Access Compliance Report

Public Rights-of-Way

(Curb Ramps)

Intersection ID: 53090	Main Street: BRADFORD_HALL_PL	Cross Street: DEERFIELD_MANOR_DR	Location:	S
ADA ID: 7C571D1EDE48	Ramp Type: Perp	Initial Pass/Fail: Fail	Overall Compliance: No	Severity Score: 10
Codes/Mitigation Info/Possible Solution		Field Measurements/Component Compliance

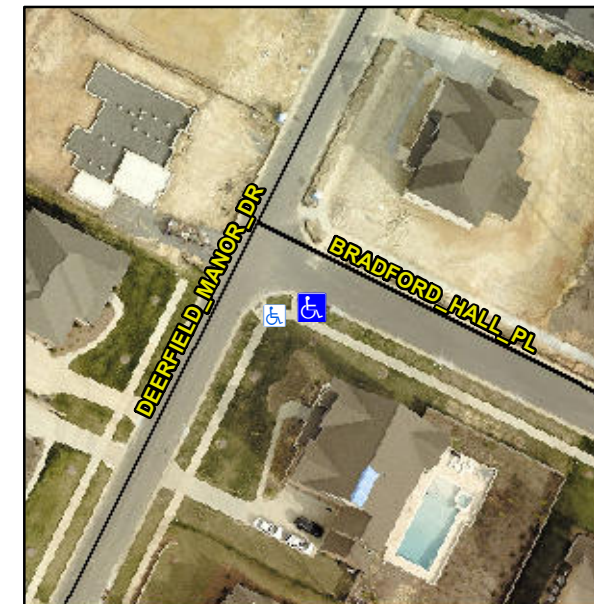
R304.5.1, R304.5.3

Compliance	Description	Data	Compliance	Description	Data
N/A	Ramp Length (in)	95.0	Yes	Ramp Slope (%)	5.2
No	Ramp Width (in)	45.5	No	Ramp XSlope (%)	4.6
N/A	Flare Type LT	N/A	N/A	Flare Type RT	N/A
N/A	Flare Slope LT (%)	N/A	N/A	Flare Slope RT (%)	N/A
N/A	Flare Traversable LT?	N/A	N/A	Flare Traversable RT?	N/A
N/A	Landing Length (in)	N/A	N/A	DWS Provided?	N/A
N/A	Landing Width (in)	N/A	N/A	DWS Contrast?	N/A
N/A	Landing Slope (%)	N/A	N/A	DWS Length (in)	N/A
N/A	Landing X Slope (%)	N/A	N/A	DWS Full Width?	N/A
N/A	Landing Curb? (Y/N)	N/A	N/A	DWS Offset (in)	N/A
N/A	Shared Landing?	N/A			
N/A	Gutter Ponding?	N/A	N/A	Gutter Slope (%)	N/A
N/A	Gutter Lip Ht (in)	N/A	N/A	Gutter X Slope (%)	N/A
N/A	Painted X Walk1?	No	N/A	Painted X Walk2?	N/A
	X Walk 1 Direction	To NE		X Walk 2 Direction	N/A
N/A	X Walk 1 Width (in)	N/A	N/A	X Walk 2 Width (in)	N/A
	X Walk 1 Slope (%)	2.3		X Walk 2 Slope (%)	N/A
	X Walk 1 X Slope (%)	3.5		X Walk 2 X Slope (%)	N/A

Remove & Replace Entire Ramp.
